Access Compliance Report Public Rights-of-Way (Curb Ramps)

Intersection ID: 32013 Main Street: RIDGE_CREK_DR Cross Street: GENERAL_DR Location: NW
ADA ID: 5B5FC749CF36 Ramp Type: Combination1Diag Initial Pass/Fail: Fail Overall Compliance: No Severity Score: 0

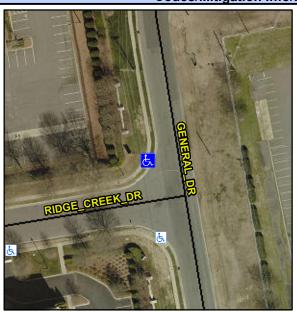
LT RP < 5%

Not Found, R304.5.1, R304.5.3

Remove & Replace Curb Ramp With Two New Directional Ramps or Equivalent.
